MEMORANDUM

General File ID or BMP ID: PC103

Christian Life Center

AS BUILT SURVEY
STORMWATER DETENTION BASIN
AND ASSOCIATED STRUCTURES
CHRISTIAN LIFE CENTER
POWHATAN DISTRICT
JAMES CITY COUNTY, VIRGINIA

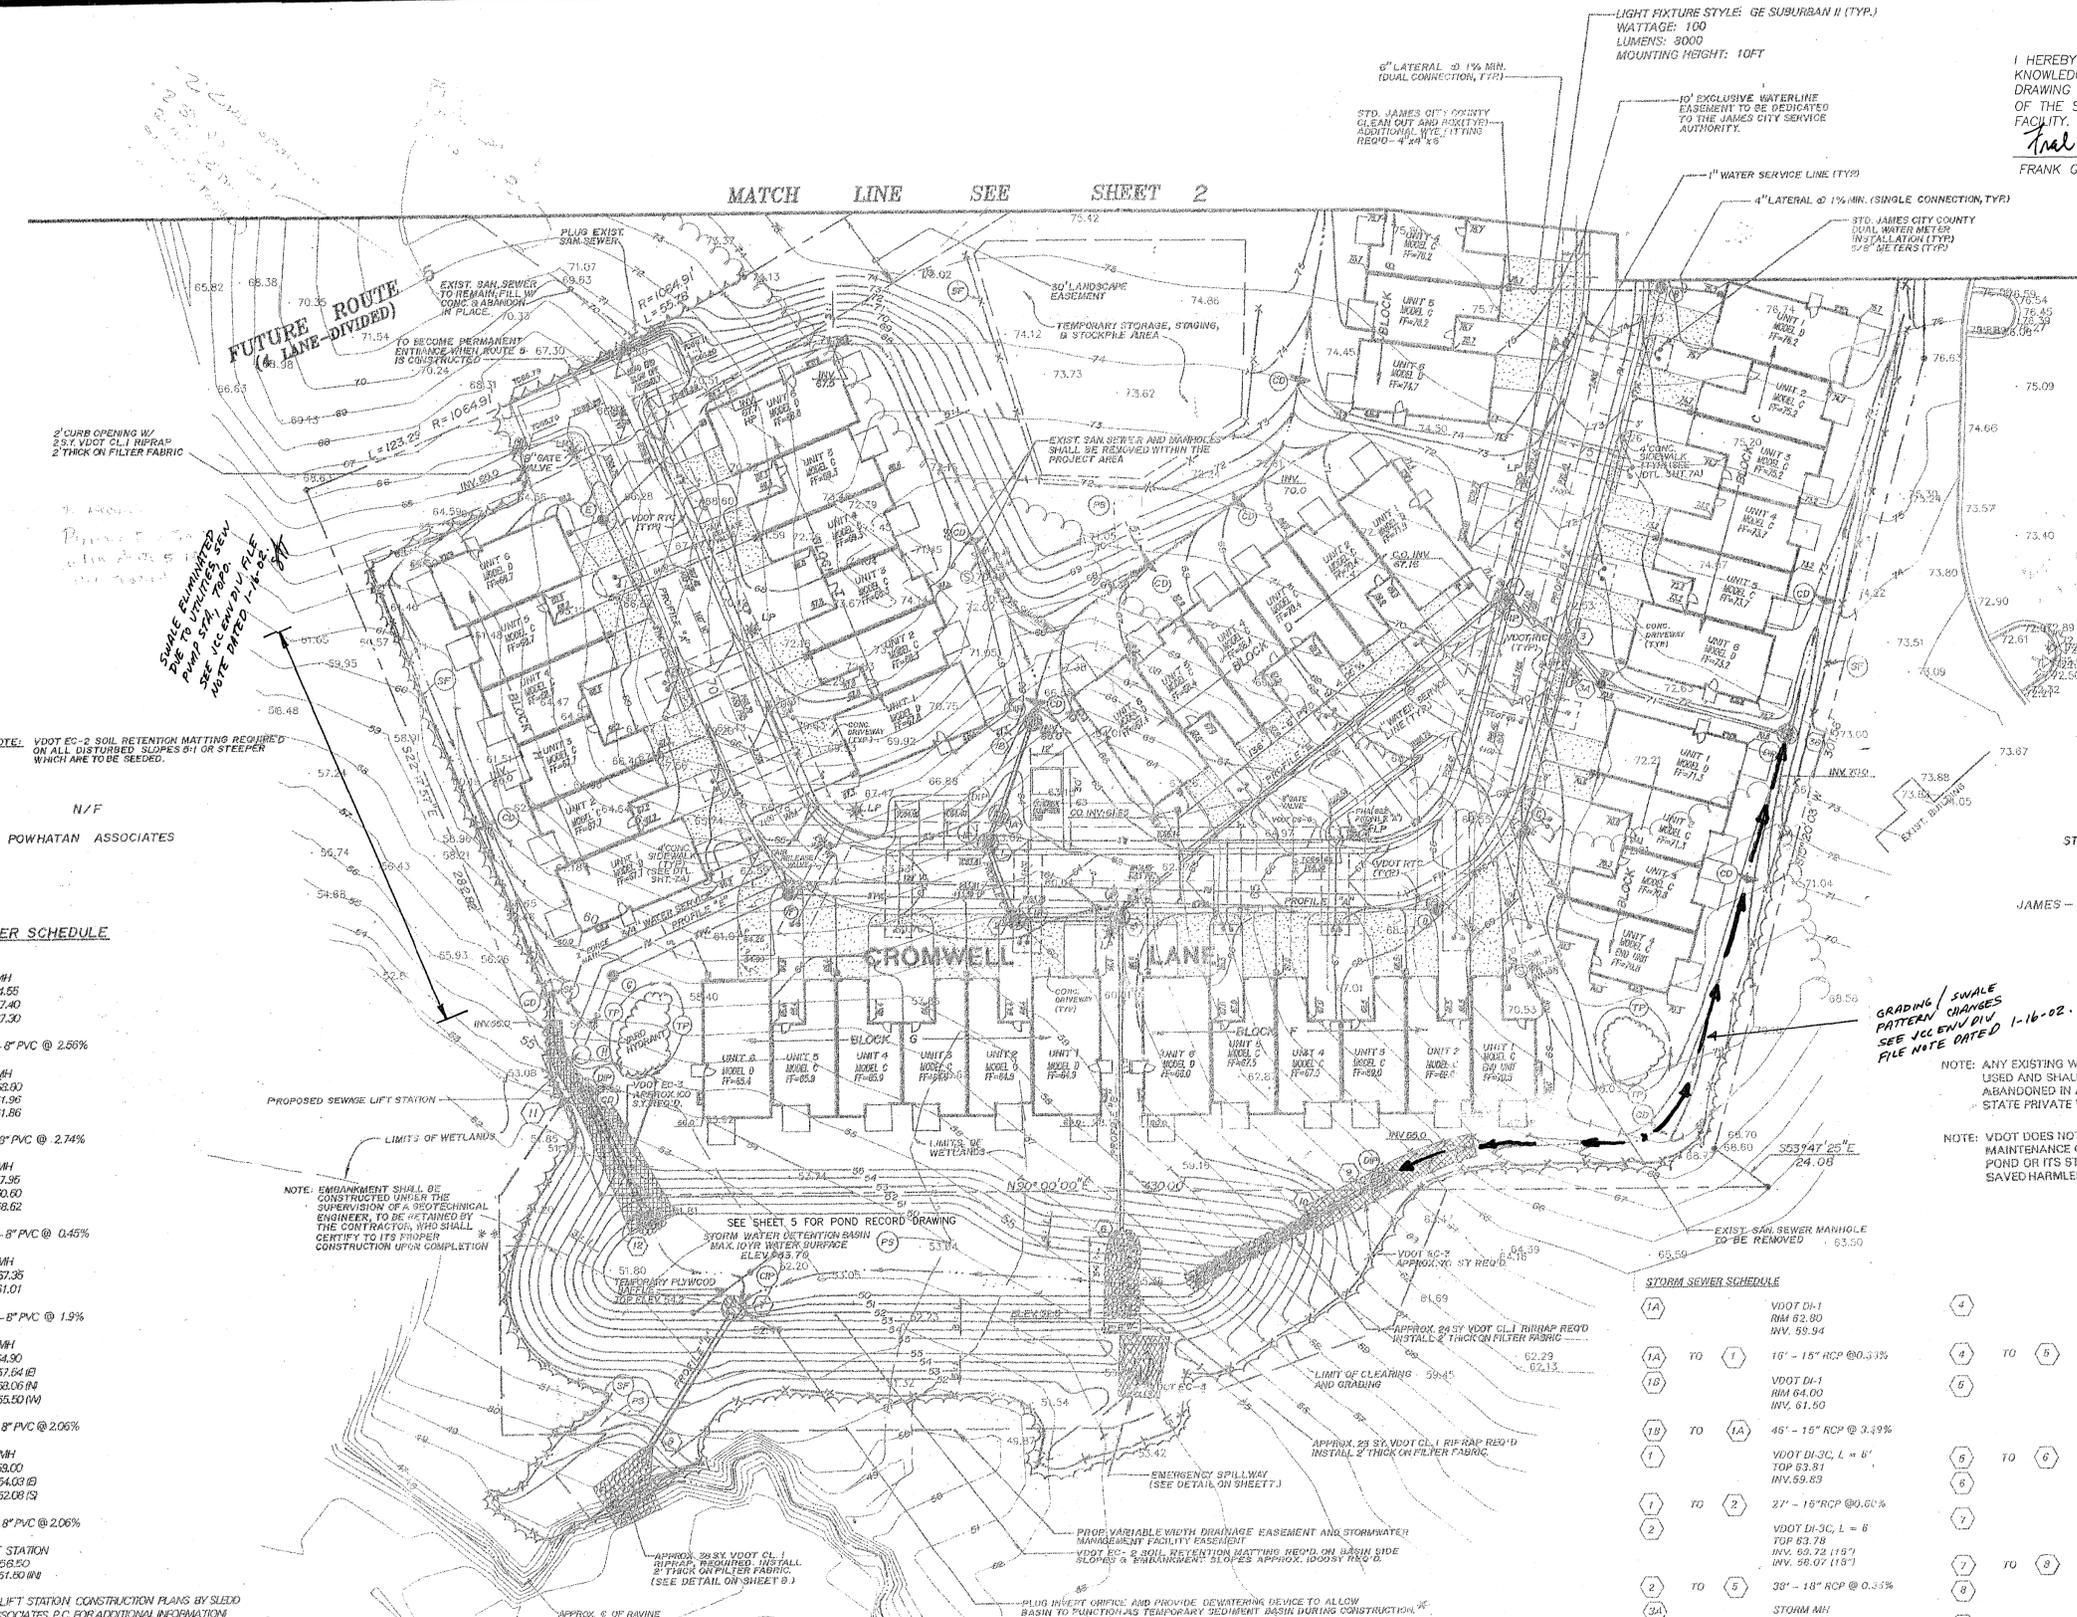
- ✓ 1. In accordance with Note # 18 on Sheet 7 of the approved plan, record drawings (as-builts) and construction certification are required for the BMP. Neither has been provided. **CC VARIANCE REQUEST**

1. In accordance with Note # 18 on Sheet 7 of the approved plan, record drawings (as-builts) and construction certification are required for the BMP. Neither were provided.

PERMANENT SWM DRY POND RISER STRUCTURE DETAIL

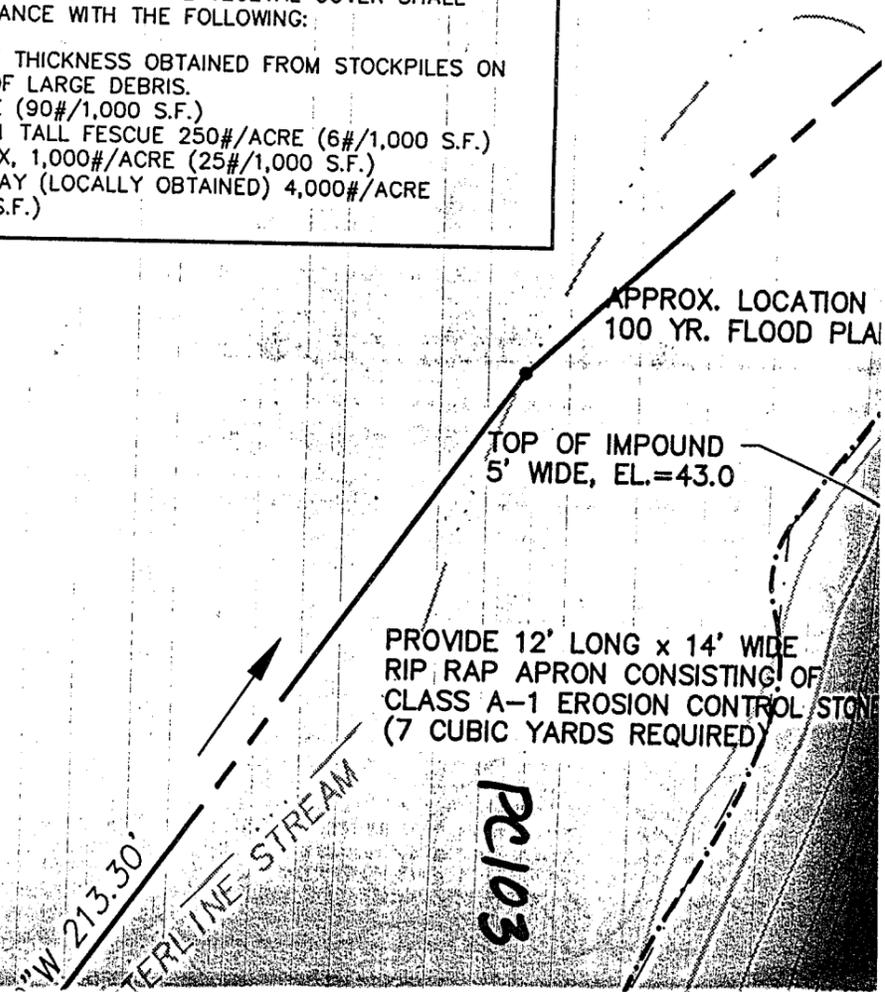
- 6. The temporary sediment basin dewatering structure (8 inch perforated pipe) needs removed and the low flow orifice converted to its approved permanent water quality control device per details on Sheet 3. The permanent low flow

6. The temporary sediment basin dewatering structure (8 inch perforated pipe) needs removed and the low flow orifice converted to its approved permanent water quality control device per details on Sheet 3. The permanent low flow orifice is to consist of a 6 inch diameter perforated PVC pipe enclosed within a # 57 coarse aggregate stone envelope.

REMOVE TEMPORARY DEWATERING RISER AND
REPLACE W/ 10 LF. OF 6" PERFORATED
POLYETHYLENE PIPE COVERED WITH #57 STONE.
